CHANGE ORDER

Project Name: **Haverhill Consentino Middle School** CO No.

Architect's Project No. **21-0818**

See attached list of 8 item(s) for a total of**\$55,398.36**

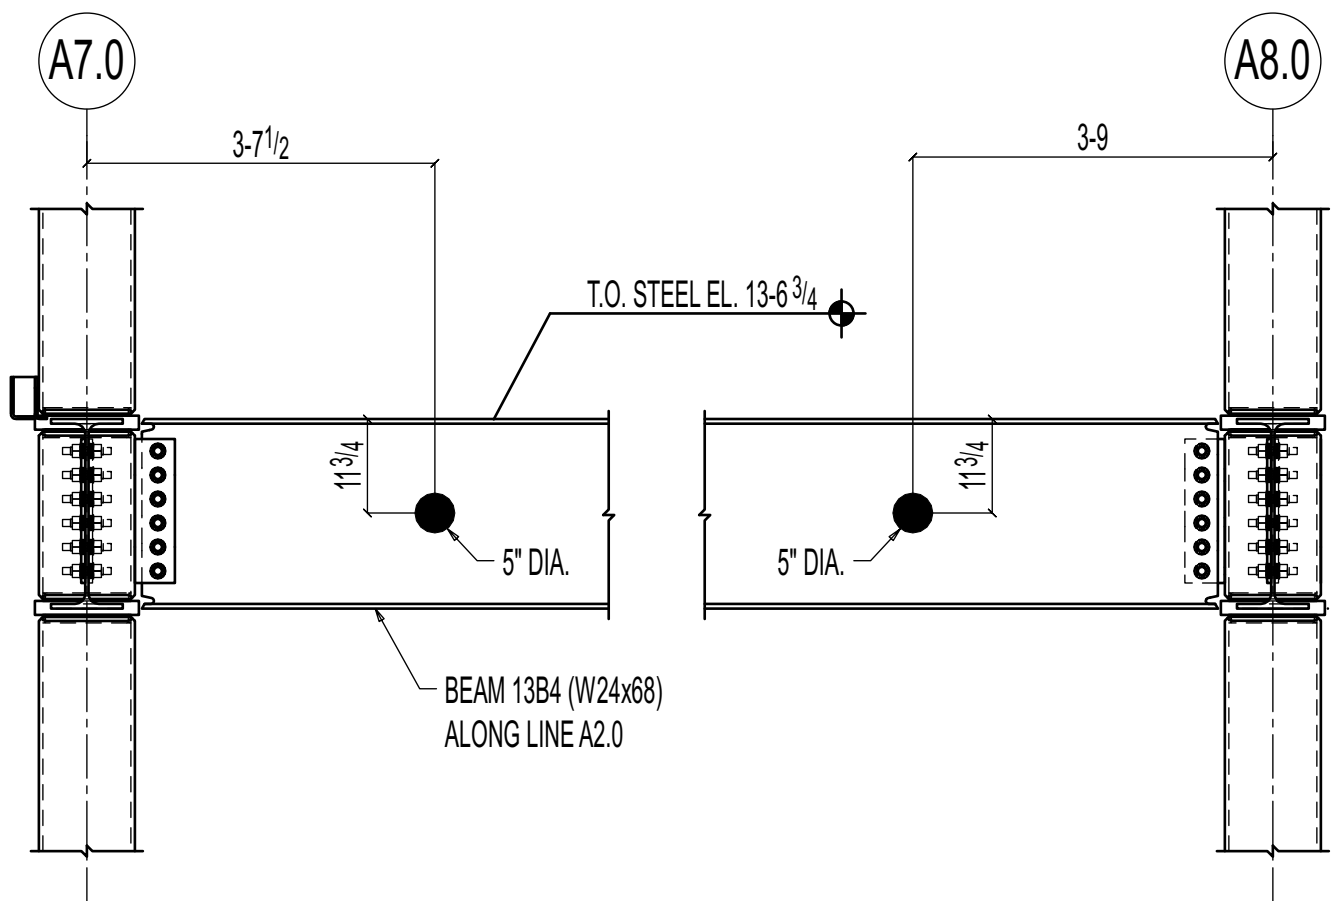
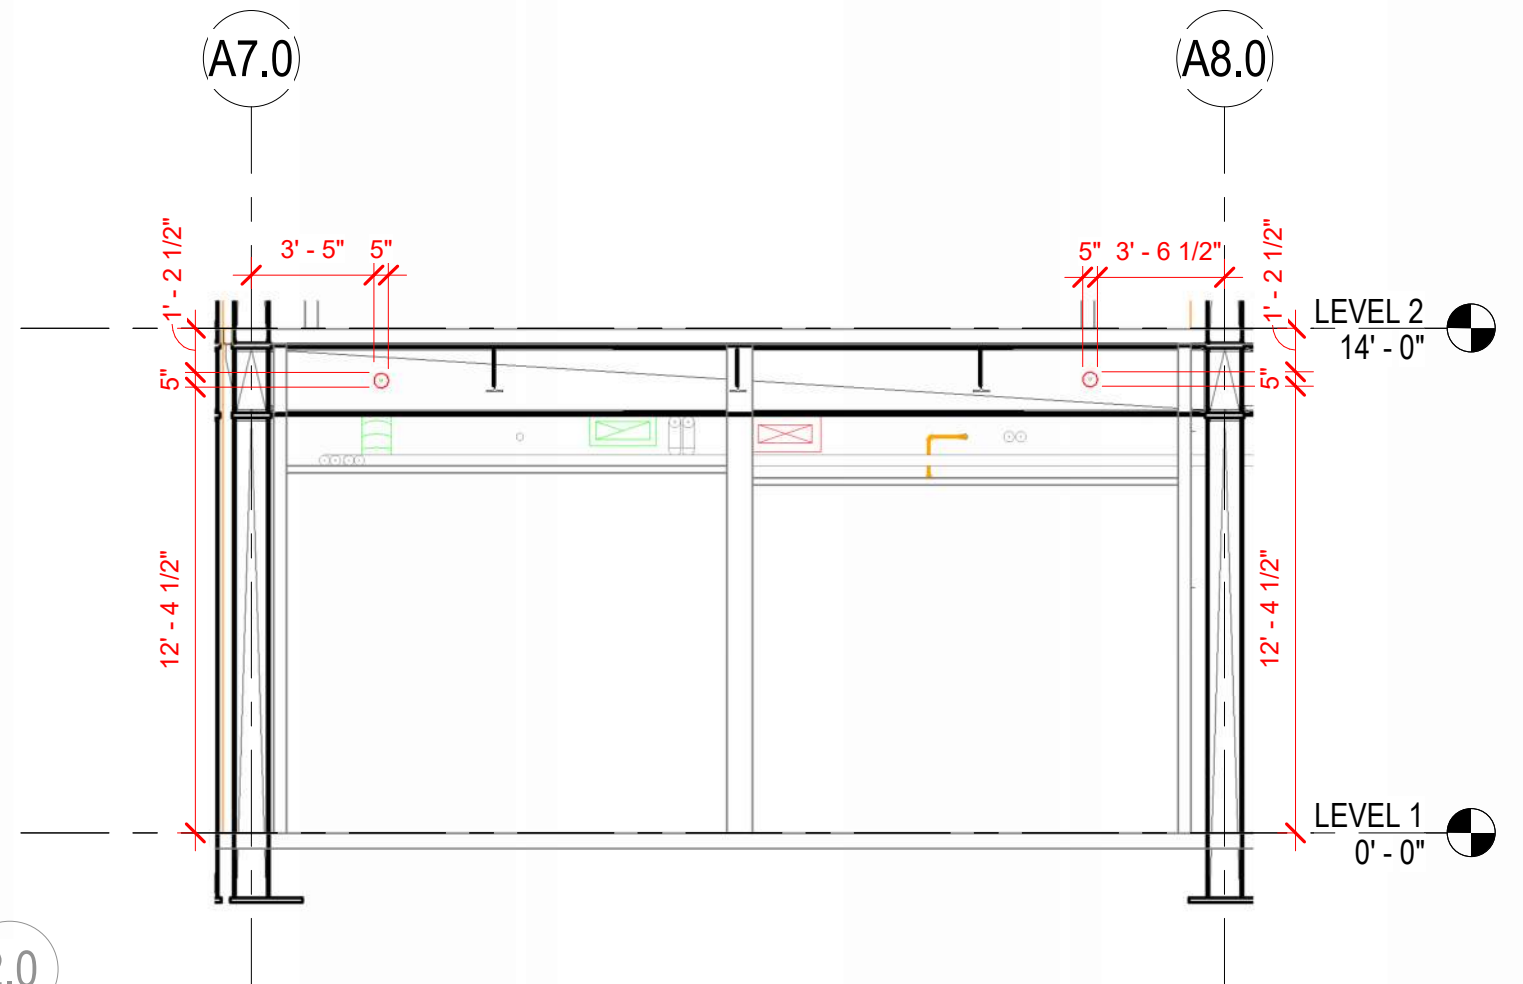
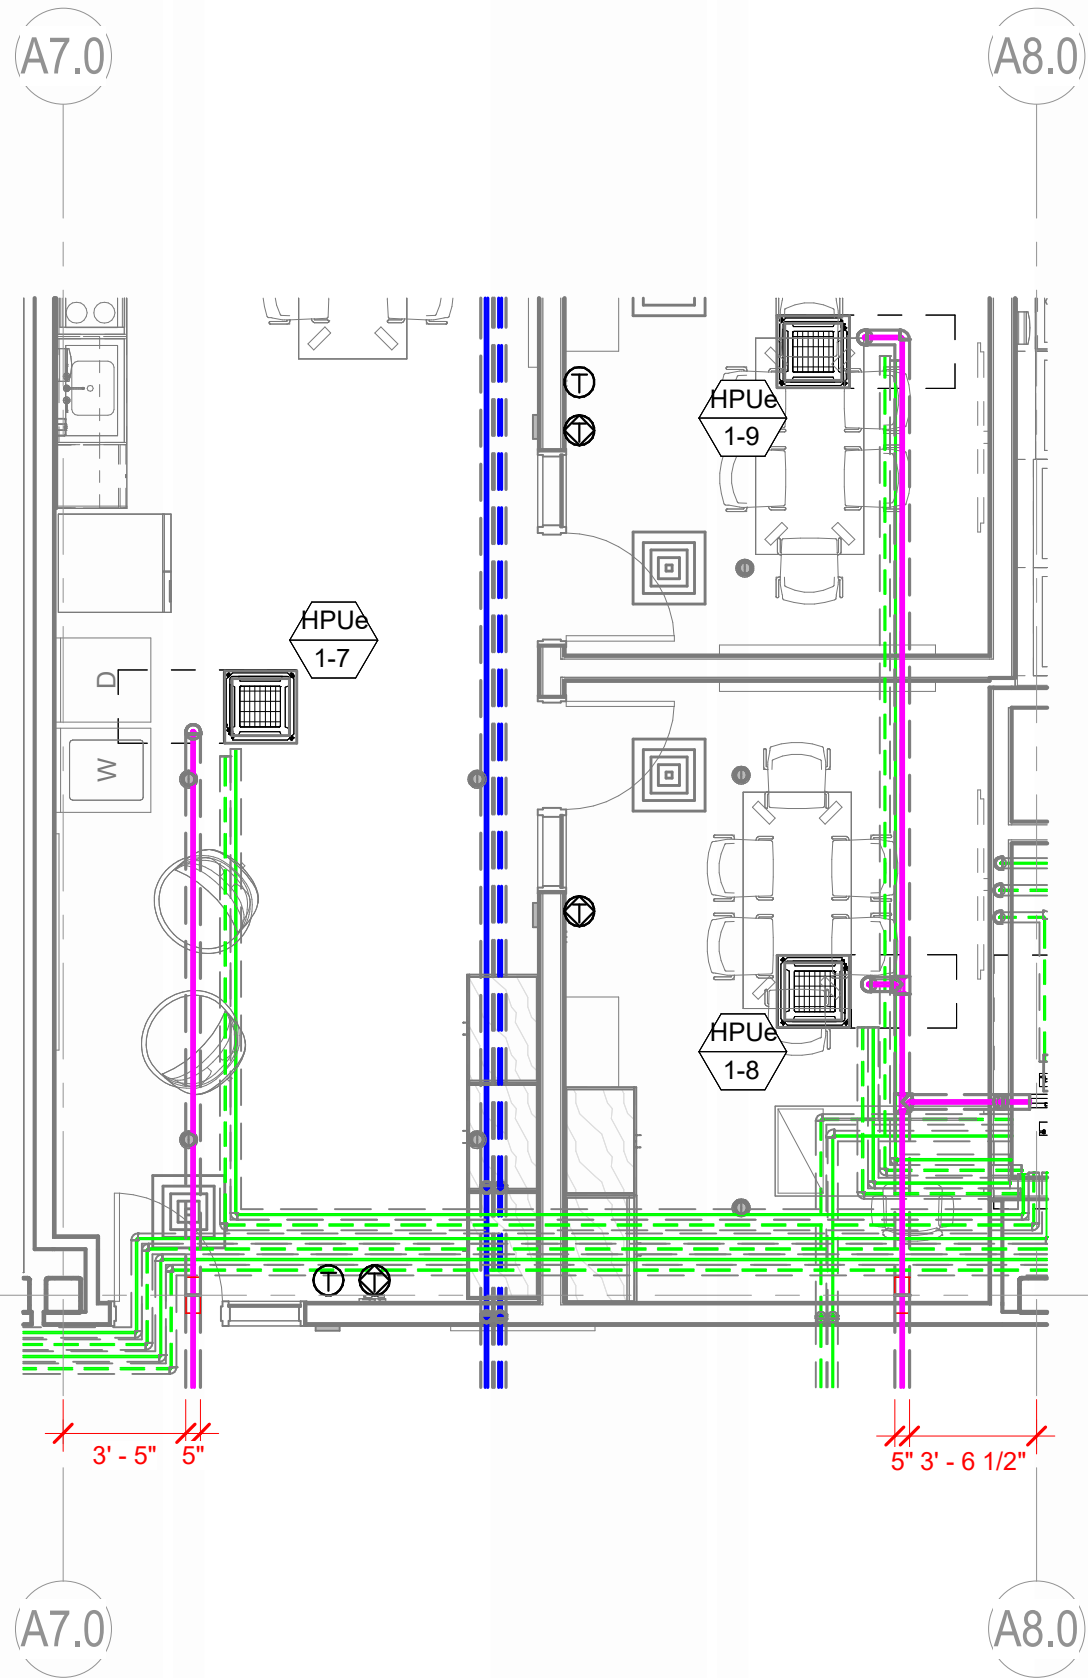
Question	<p>Question from Jake McDonough Brait Builders Corporation on Friday, Aug 30, 2024 at 09:59 AM EDT</p> <p>Above Rooms 1098 and 1100, Condensate lines from HPUE 1-7, 1-8, and 1-9 require (2) 5" diameter beam penetrations through structure along grid 2.0 between A7.0 and A8.0. See attached for reference, please confirm or advise otherwise.</p> <p>Attachments CMS - RFI 121 - GMC RFI - 07 Request For Beam Penetrations.pdf</p>
----------	---
